Department of Transportation

MEMORANDUM

DATE: January 22, 2019

SUBJECT: ZC Case No. 02-38 J – 1000 4th Street SW (Waterfront Station)

Figure 1 – Site Plan (Source: CTR, Gorove/Slade, Figure 6, 11/28/18)

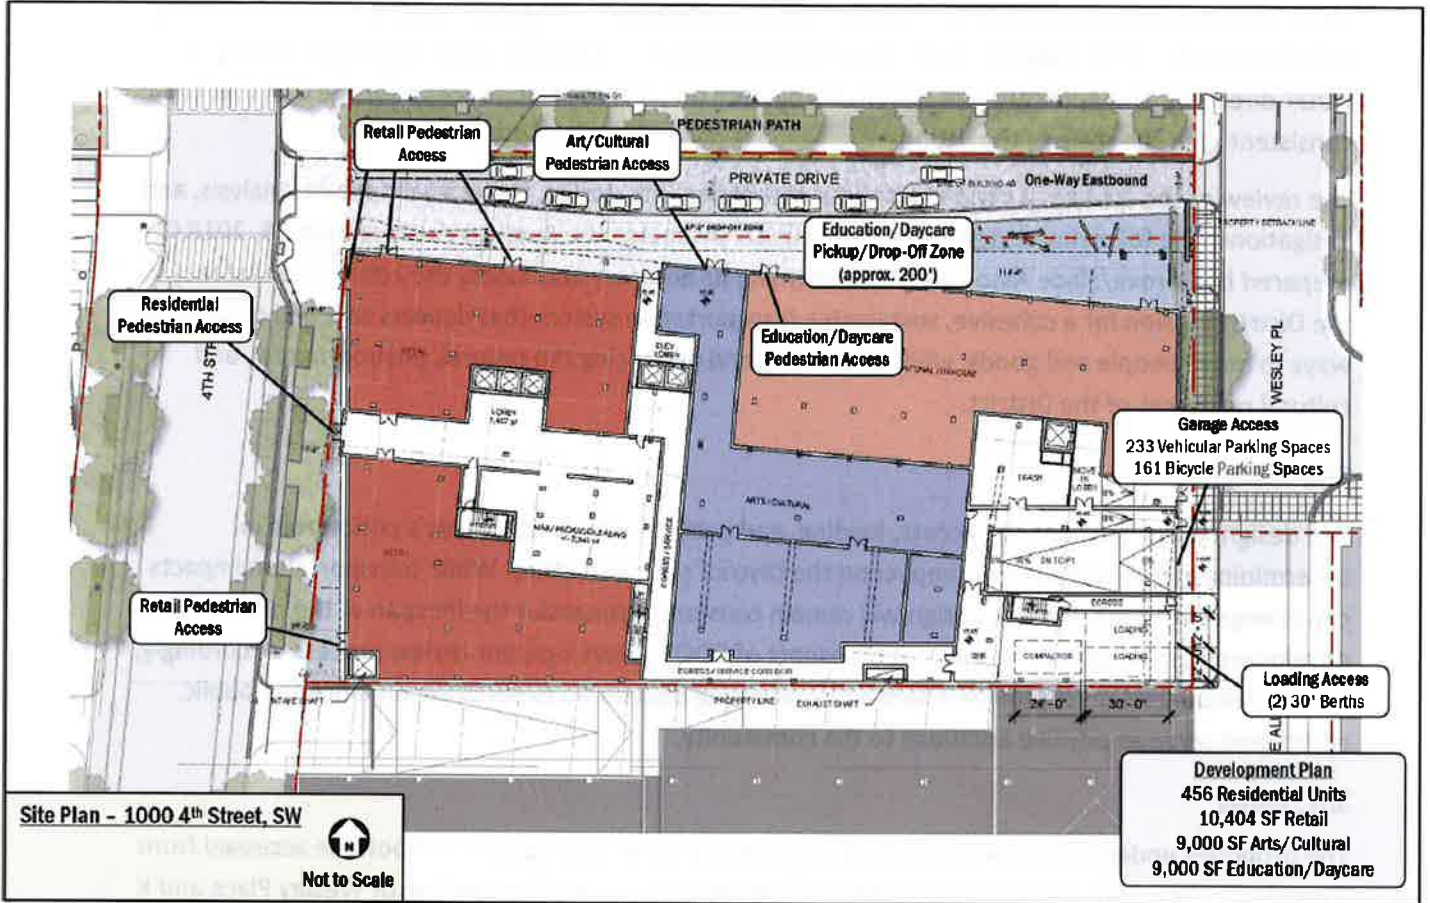
It is noted that the latest Ground Floor Plan on the record (page 36 of Exhibit 22G3, dated 1/11/19) does not show the two (2) ZR16-required loading platforms at the rear of the loading berths. However, the Applicant has subsequently provided an updated graphic to DDOT on 1/14/19 with the platforms. DDOT is in concurrence with the proposed loading scheme as shown in Figure 1 above, so long as the final

planset decided on by the Zoning Commission includes the revised graphic showing loading platforms and the Applicant provides a contingency for trucks larger than 30-feet in length. DDOT recommends the Applicant revise the Loading Management Plan to prohibit trucks larger than 30-feet from loading or unloading on 4th Street or Wesley Place SW. These trucks should make their deliveries on either the private drive or in the private loading area south of Wesley Place.

- Provide a revised Ground Floor Plan (page 36 of Exhibit 22G3) showing the inclusion of two (2) loading platforms at the rear of the loading berths;
- Pursue a surface easement through the Office of the Surveyor for the one-way eastbound private road to ensure vehicles and pedestrians can freely utilize it;

Figure 6 – Existing Pedestrian Infrastructure (Source: CTR, Gorove/Slade, Figure 21, 11/28/18)

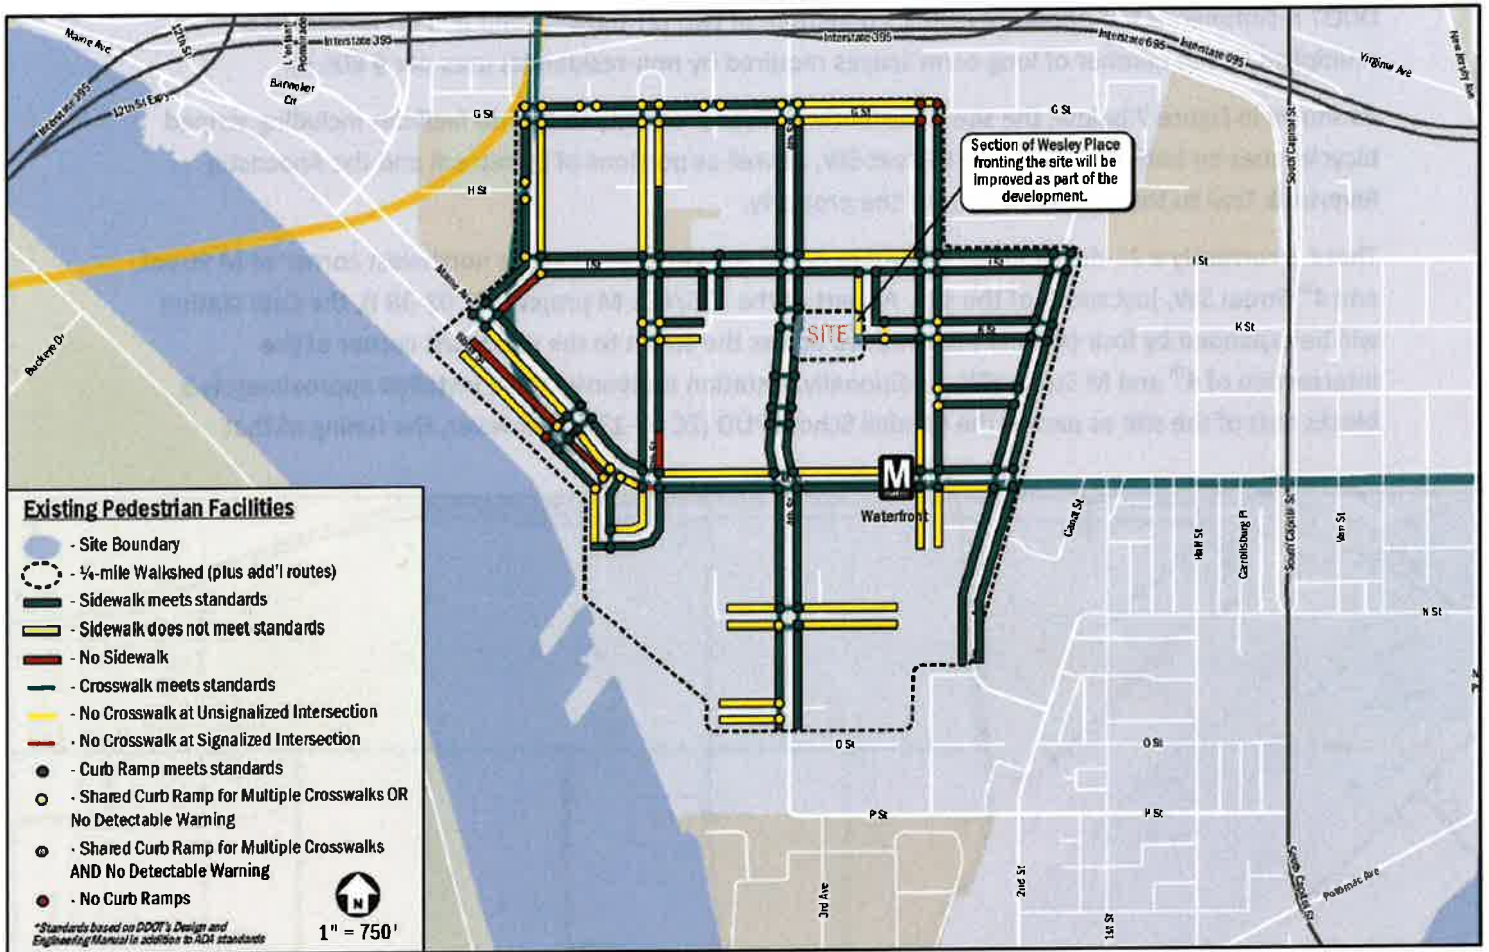
The CTR’s inventory of existing pedestrian infrastructure, as shown in Figure 6 below, demonstrates that most sidewalks and curb ramps in the vicinity of the site are currently consistent with DDOT standards. While there are a few missing or substandard segments of sidewalk and curb ramps in the wider area, the existing pedestrian network along major pathways to schools, attractions, and the Metrorail station is generally adequate.

It is noted that the Applicant is proposing to upgrade the sidewalk on the eastern site frontage (western side of Wesley Place SW) between the private drive and the southern edge of the site to meet DDOT standards. This includes a sidewalk of at least 6 feet wide and tree boxes. Additionally, the Applicant is proposing to upgrade the southern leg of the Wesley Place and K Street intersection to provide a raised

curb cut and sidewalk Wesley Place. DDOT concurs with this proposal as it will better delineate the public roadway network from the private loading area for the project and neighboring building.

Figure 7 – Existing and Proposed Bicycle Facilities (Source: CTR, Gorove/Slade, Figure 22, 11/28/18)

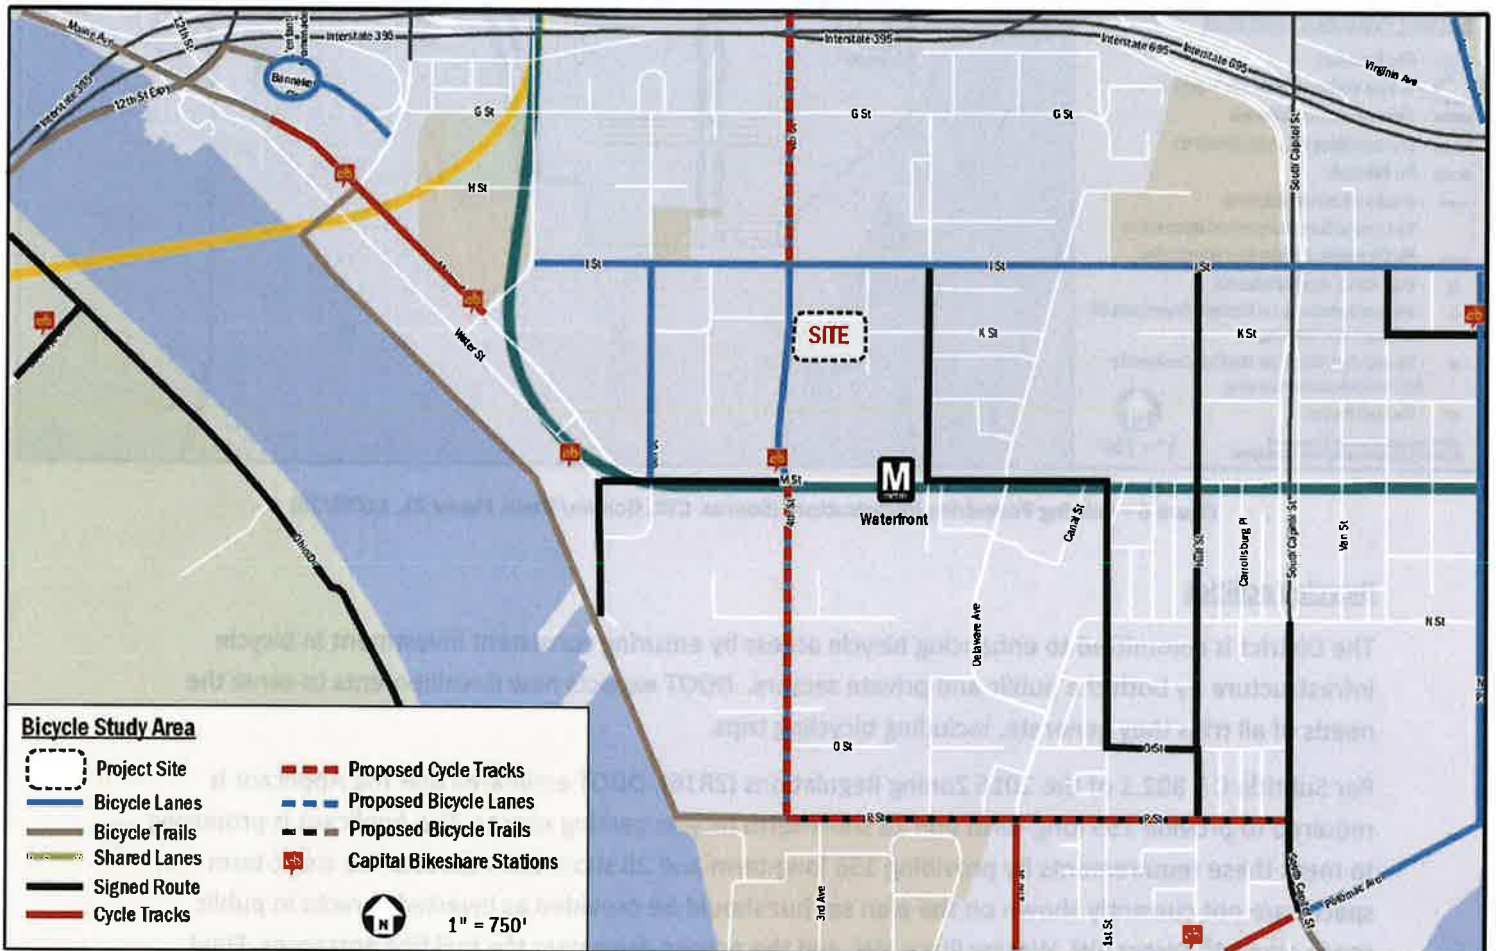
As shown in Figure 7 below, the site is currently in close proximity to bicycle facilities including striped bicycle lanes on both 4th Street and I Street SW, as well as portions of cycletrack and the Anacostia Riverwalk Trail to the south and west of the property.

There is currently a 21-dock Capital Bikeshare (CaBi) station located at the northwest corner of M Street and 4th Street SW, just south of the site. As part of the 375/425 M project (ZC 02-38 I), the CaBi station will be expanded by four (4) docks and moved across the street to the northeast corner of the intersection of 4th and M Street SW. Additionally, a station is planned to be installed approximately 3 blocks east of the site as part of the Randall School PUD (ZC 07-13G). However, the timing of that

- Fund and install a 19-dock Capital Bikeshare (CaBi) station and fund one-year of maintenance and operations costs. This will help relieve the currently stressed station at 4th and M Street SW. Work with DDOT CaBi staff on a final location of the station, ideally in the immediate vicinity of 4th and I Street SW, but not east of 3rd Street SW since a station is already planned as part of the Randall School project;
